FIRST DRAFT MINUTES

September 19, 2013 Standards Committee Meeting (Changes by the Action of the Committee shown highlighted **yellow**)

RE: Minutes from the September 19, 2013 Standards Committee Meeting

STANDARD DRAWING NO. E 802-SCSB-06

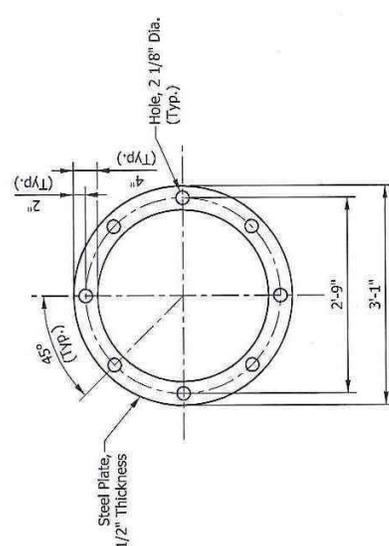
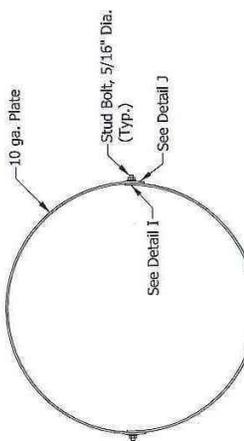
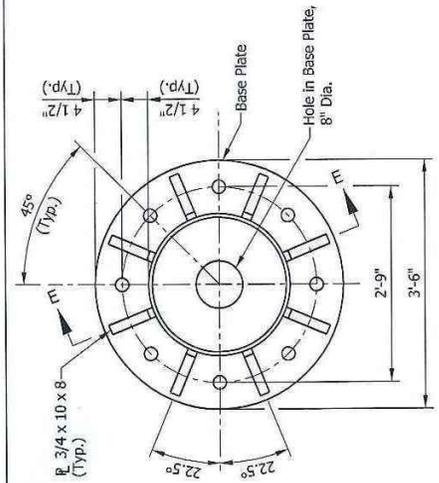
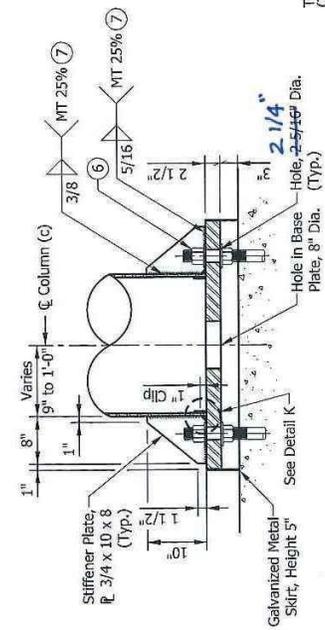
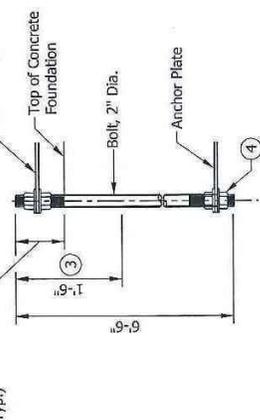
DISCUSSION: Mr. Miller requested a motion to accept the minutes from the last meeting, as revised by Mr. Hanza. Mr. Boruff and Mr. Hanza briefly explained the revisions made to the attached drawings (pg 4 thru 7). Mr. Buening also requested a revision to RSP 401-R-581 concerning the joint adhesive temperature range to read:

1. APPROVAL OF THE MINUTES FROM THE JUNE 20, 2013 MEETING.
 PROPOSED REVISION TO ITEM 04 (WITH MARKUPS).

5th paragraph: "The sealant temperature at the time of application shall be at least 135 ±5°F and shall not exceed 180°F." Mr. Keefer motioned to accept the minutes as presented with these revisions. Mr. Boruff seconded the motion.

802-SCLS-12 SIGN CANTILEVER STRUCTURE DOUBLE ARM AND QUADRI-CHORD BASE PLATE, ANCHOR BOLT, AND METAL SKIRT DETAILS (WITH MARKUPS)

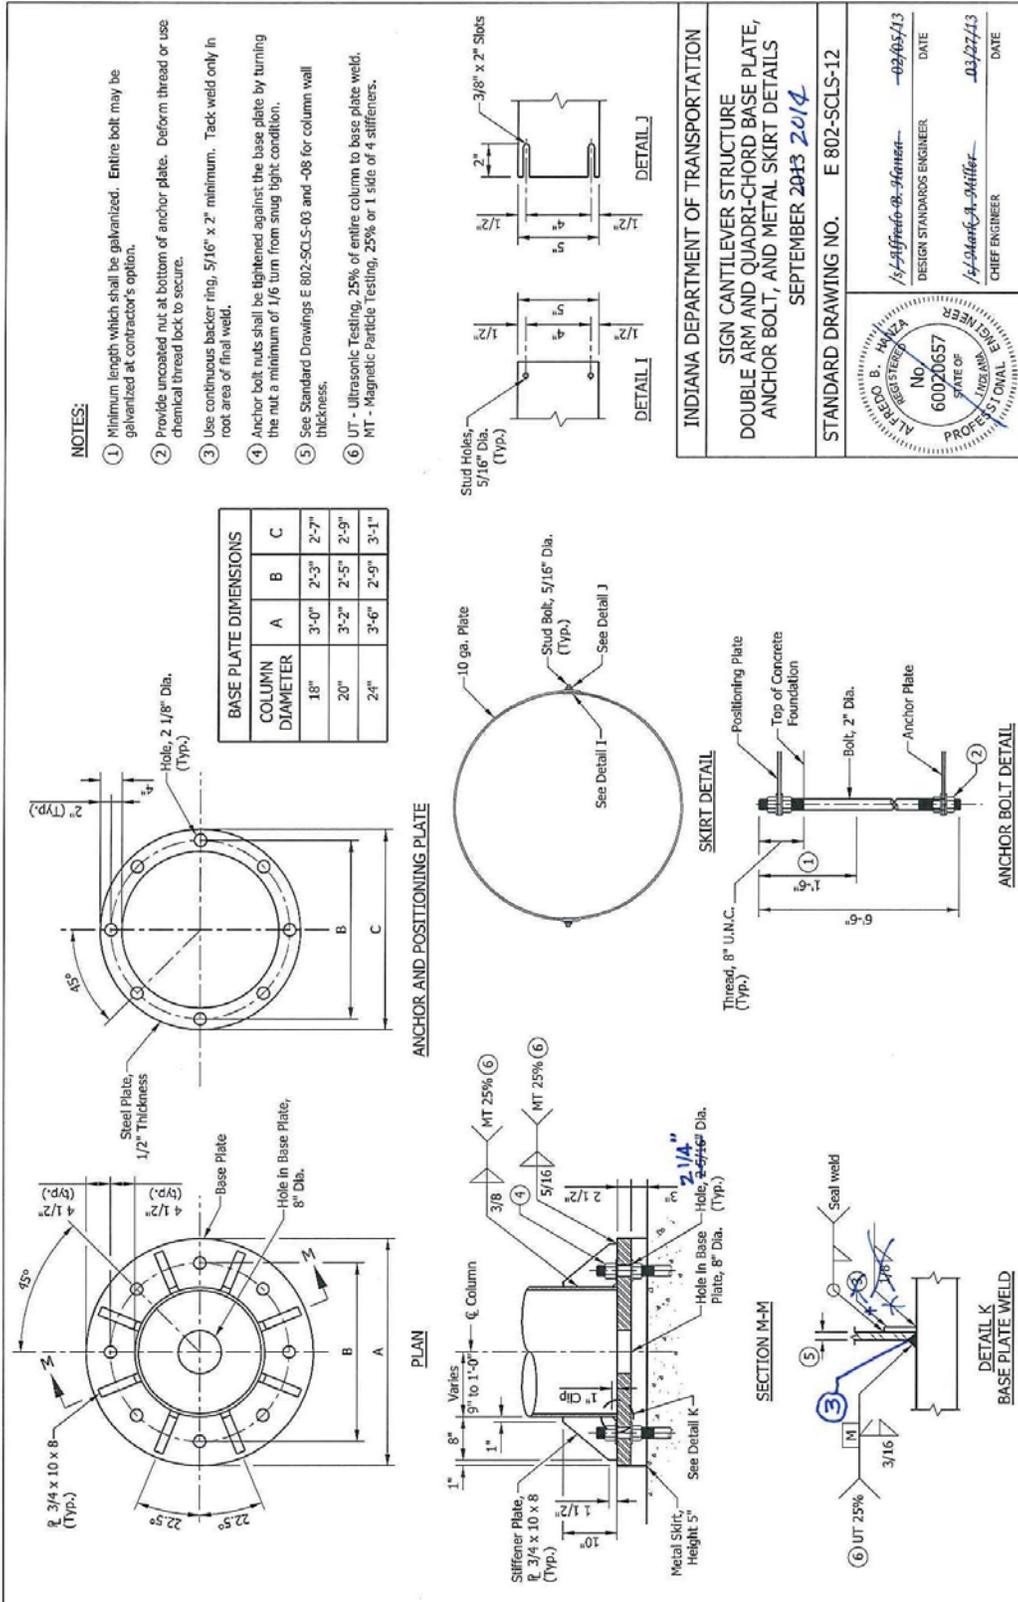
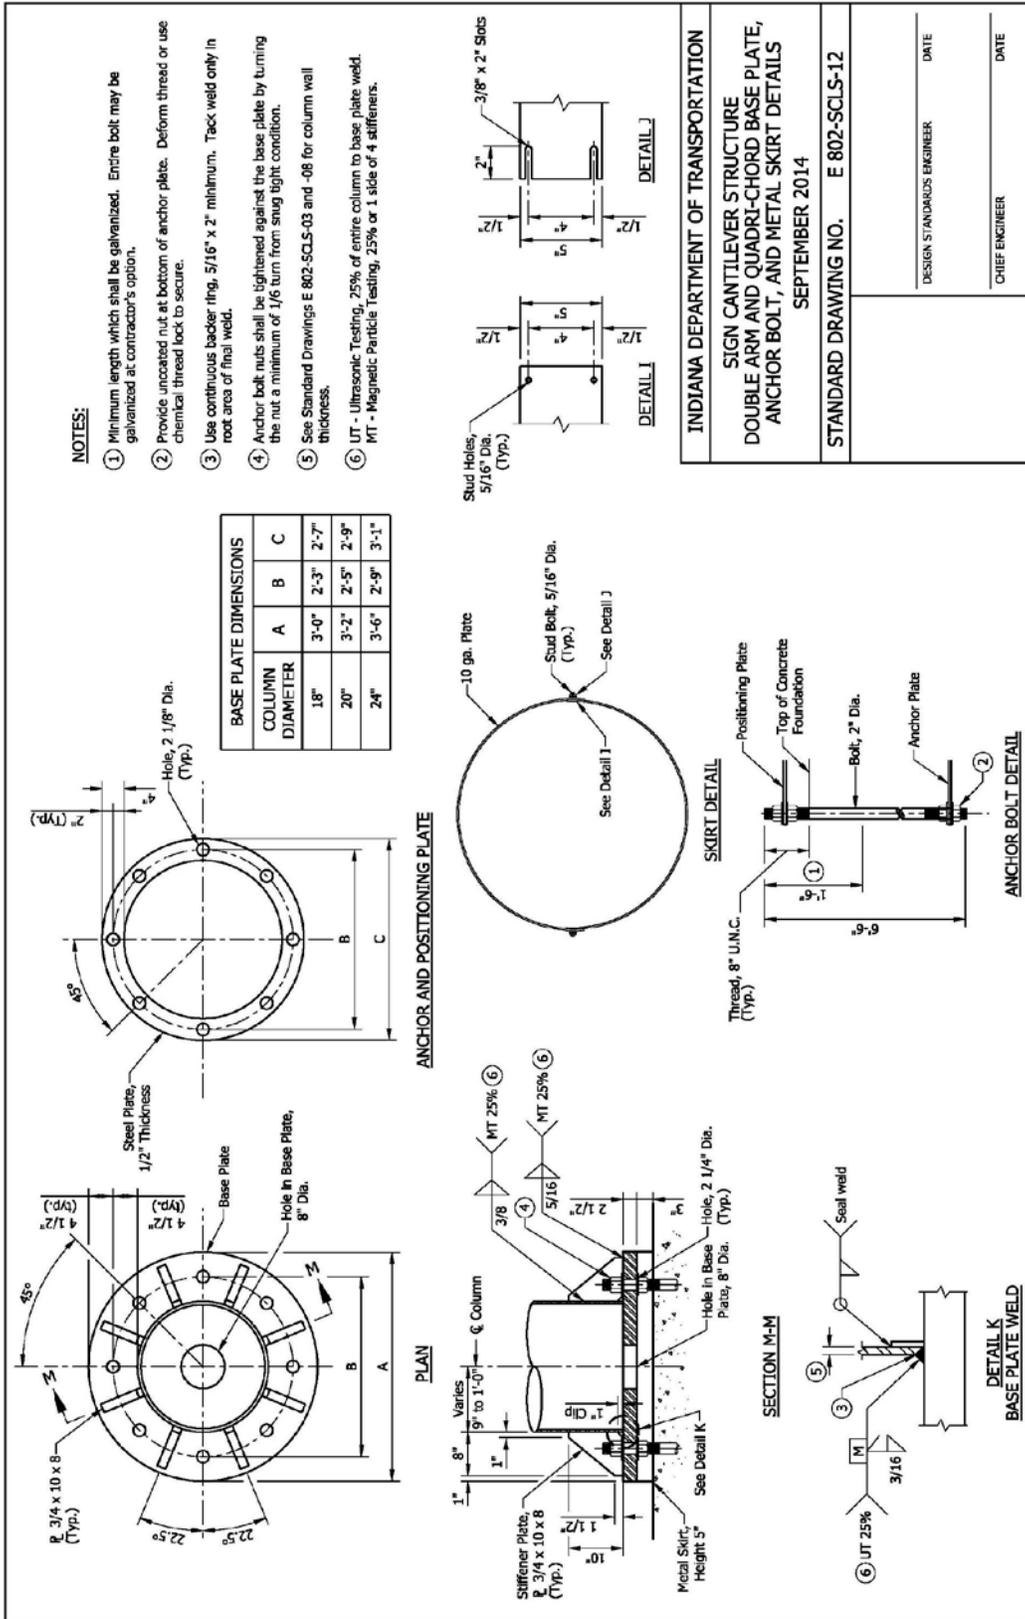
PROBLEM(S) ENCOUNTERED: Sign and signal cantilever structure welding details in certain locations (base plate, arm connection) are not practical to do as shown on current standard drawings. In addition, diameter of base plate hole for anchor bolts in sign cantilever drawing is not consistent with manufacturing practice.

DISCUSSION: This item was introduced and presented by Mr. Boruff who expressed the need to revise the shown current standard drawings to reflect current manufacturing practice and AASHTO requirements. These revisions also coincide with previously approved revisions to the last meetings minutes.

PROPOSED SOLUTION: Revise the welding details (still meeting AASHTO requirements) and change anchor bolt hole diameter from 2 5/16" to 2 1/4" .
